# SAN FRANCISCO PLANNING DEPARTMENT

## Discretionary Review Full Analysis

*Date:* February 2, 2017  
*Case No.:* 2014.0086DRP-02  
*Project Address:* 2855 FILBERT STREET  
*Permit Application:* 2013.10.04.8576 (New Construction)  
*Zoning:* RH-1 (Residential House, One-Family)  
40-X Height and Bulk District  
*Block/Lot:* 0948/029  
*Project Sponsor:* Stephen Sutro  
Sutro Architects  
1055 Post Street  
San Francisco, CA 94109  
*Staff Contact:* Brittany Bendix – (415) 575-9114  
[Brittany.bendix@sfgov.org](mailto:Brittany.bendix@sfgov.org)  
*Recommendation:* **Do not take DR and approve the project as proposed.**

## EXHIBIT F

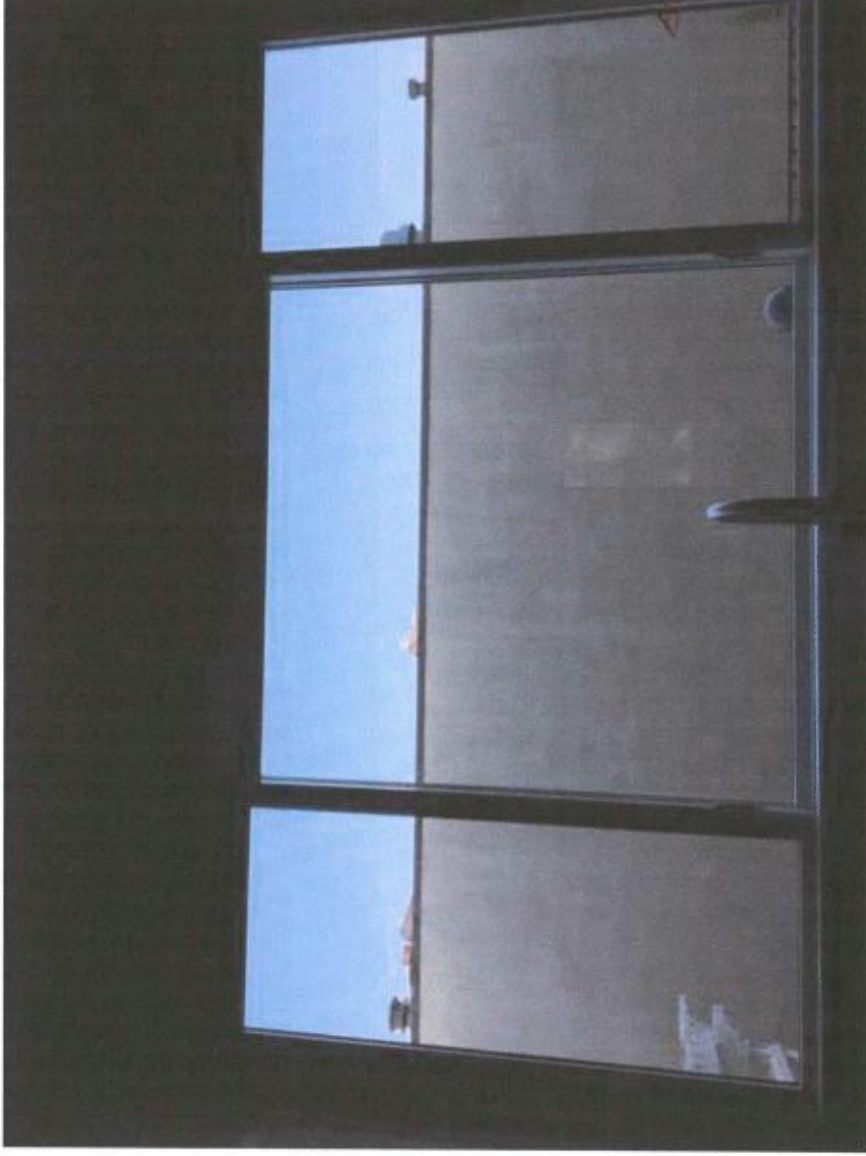
In the same way, the project's mass will overwhelm key living areas of 2857 Filbert because that townhome only gets its light and air from the Southern and Northern exposures. The combination of added height and depth of the new building on its East side, along with the high rear fences and building walls of the Lyon street homes that face the entirety of its West side property line, will further box-in 2857 Filbert. (EXHIBIT F)

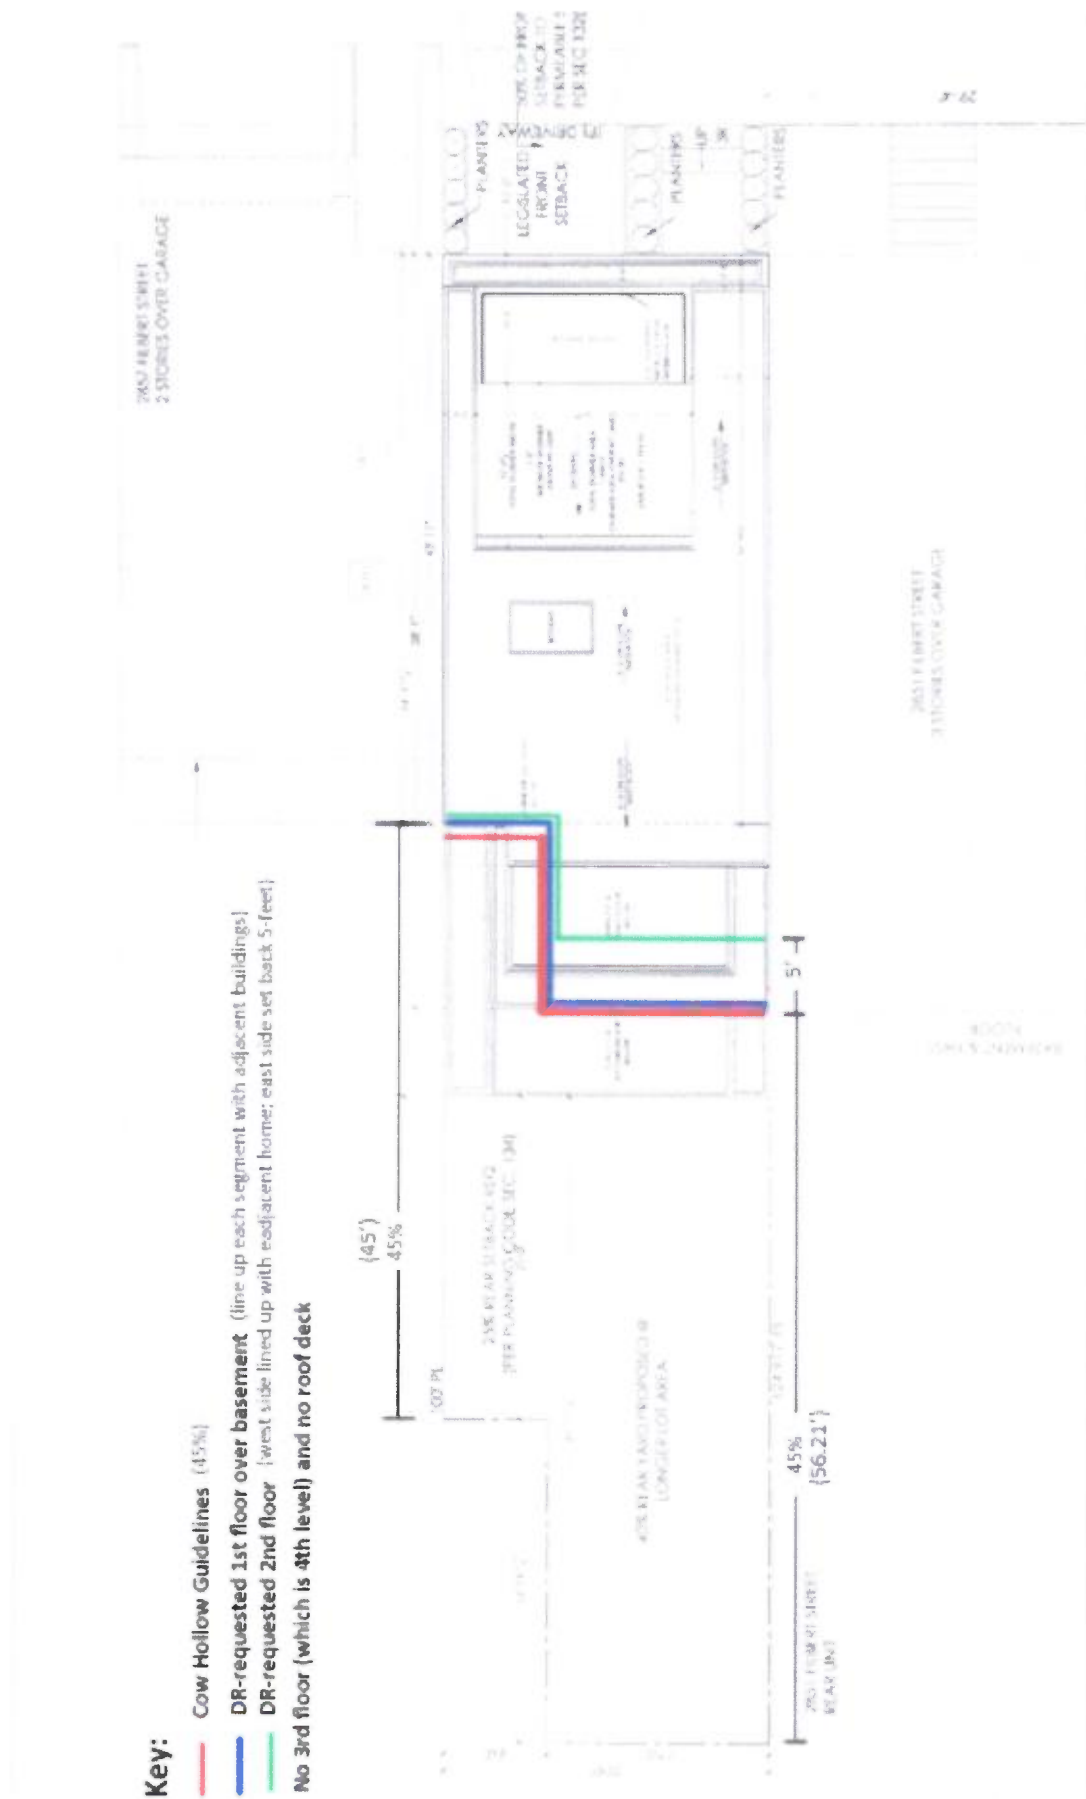
NEW HOUSE AT 2851  
WILL HAVE A FLAT ROOF  
AND RESPECTS THE GENTLE UPSLOPE  
OF FILBERT STREET

THE EXISTING HOME ON THE SUBJECT LOT  
(2855 FILBERT ST) HAS A FLAT ROOF AND  
RESPECTS THE STREET SLOPE

NOTE :  
THE PROPOSED HOUSE WILL BE THE ONLY ONE  
ON THE BLOCK FACE WITHOUT A FLAT ROOF AND  
WITH A ROOF THAT RISES A FULL FLOOR ABOVE  
THE UNBROKEN ROW OF ROOFLINES

## EXHIBIT D

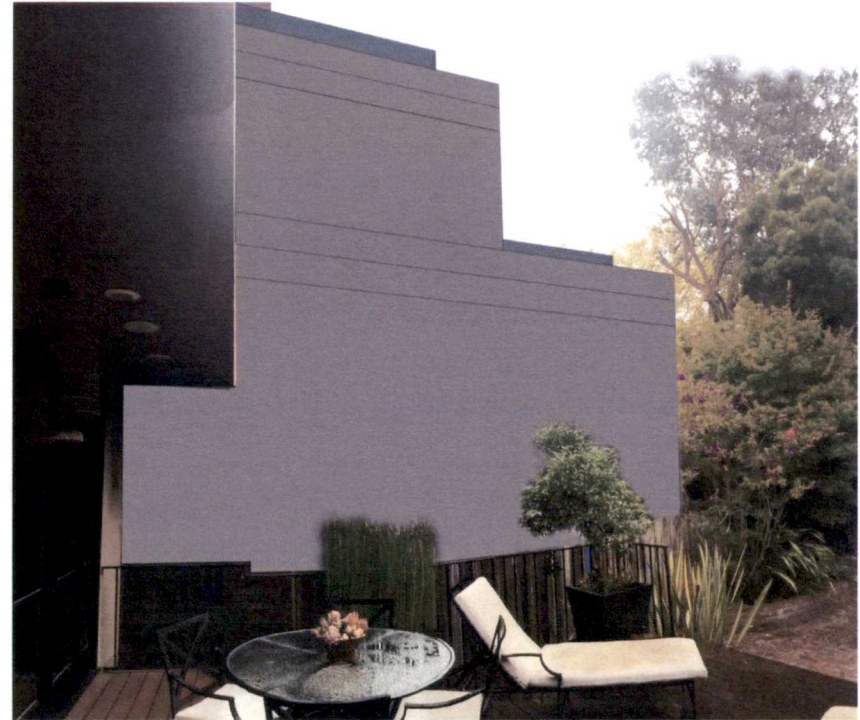
From deck, 2857 Filbert  
**EXISTING CONDITION**

From deck, 2857 Filbert  
**AFTER PROPOSED PROJECT**

# EXHIBIT K

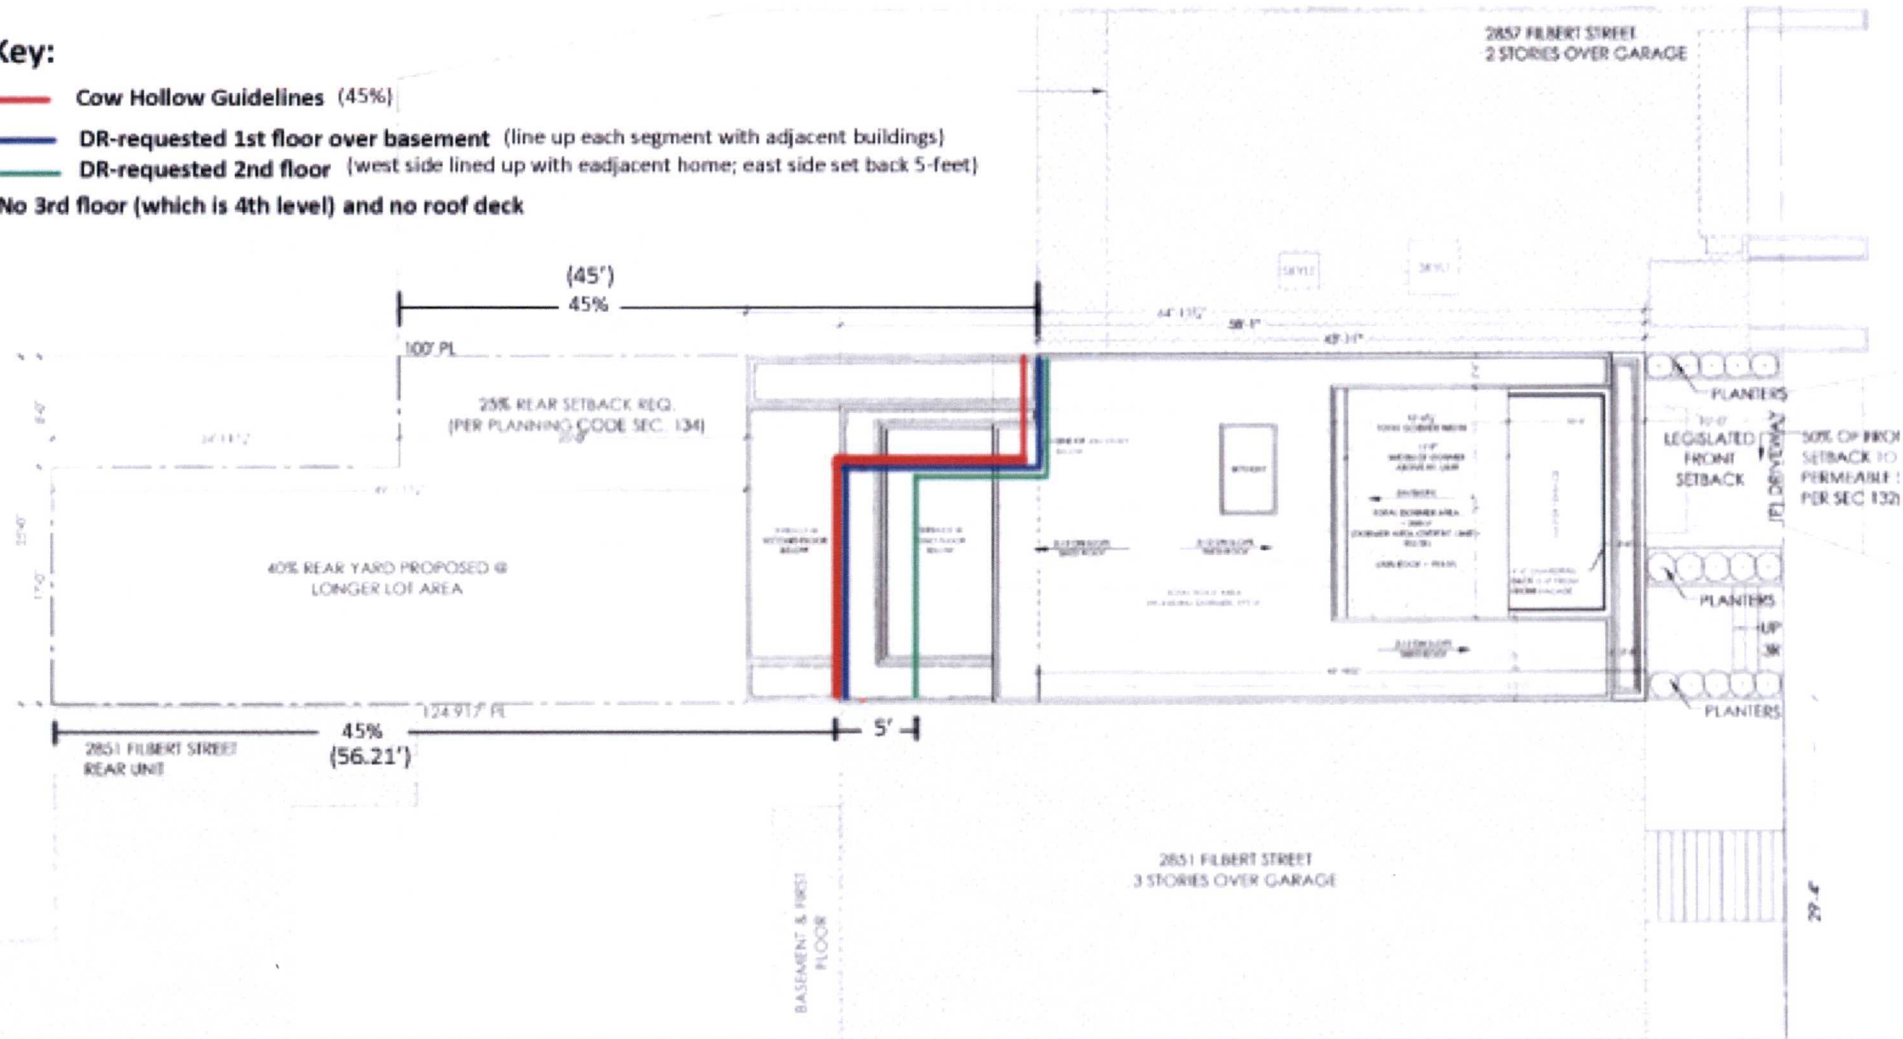
**Our requested depth change (Exhibit K) asks that the property meet the 45% open space requirement of the Cow Hollow Guidelines on the ground level, with a second floor setback reflecting and respecting the much shorter adjacent building at 2857 Filbert. This proposal reflects:**

## EXHIBIT L

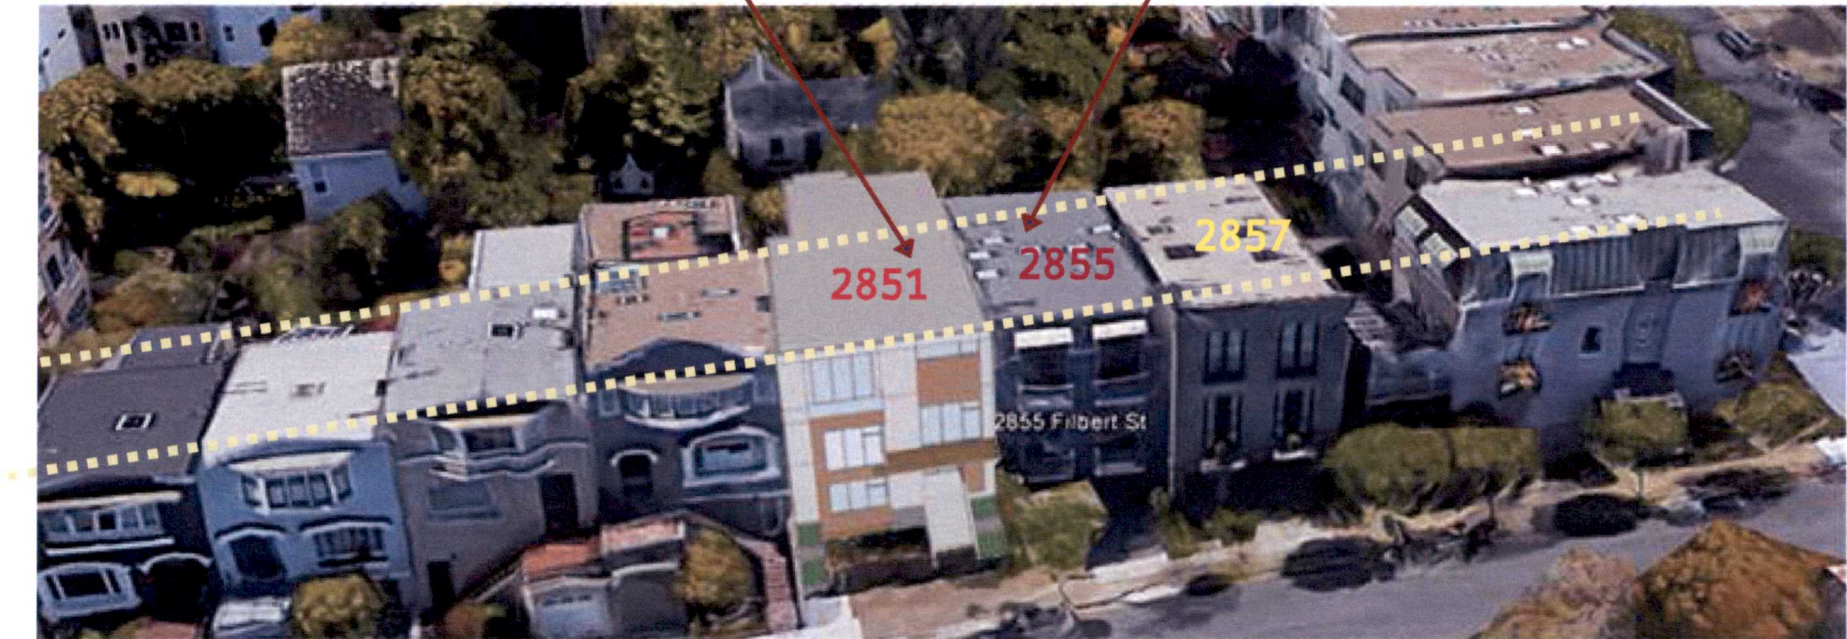
NEW HOUSE AT 2851  
WILL HAVE A FLAT ROOF  
AND RESPECTS THE GENTLE UPSLOPE  
OF FILBERT STREET

THE EXISTING HOME ON THE SUBJECT LOT  
(2855 FILBERT ST) HAS A FLAT ROOF AND  
RESPECTS THE STREET SLOPE

NOTE :  
THE PROPOSED HOUSE WILL BE THE ONLY ONE  
ON THE BLOCK FACE WITHOUT A FLAT ROOF AND  
WITH A ROOF THAT RISES A FULL FLOOR ABOVE  
THE UNBROKEN ROW OF ROOFLINES
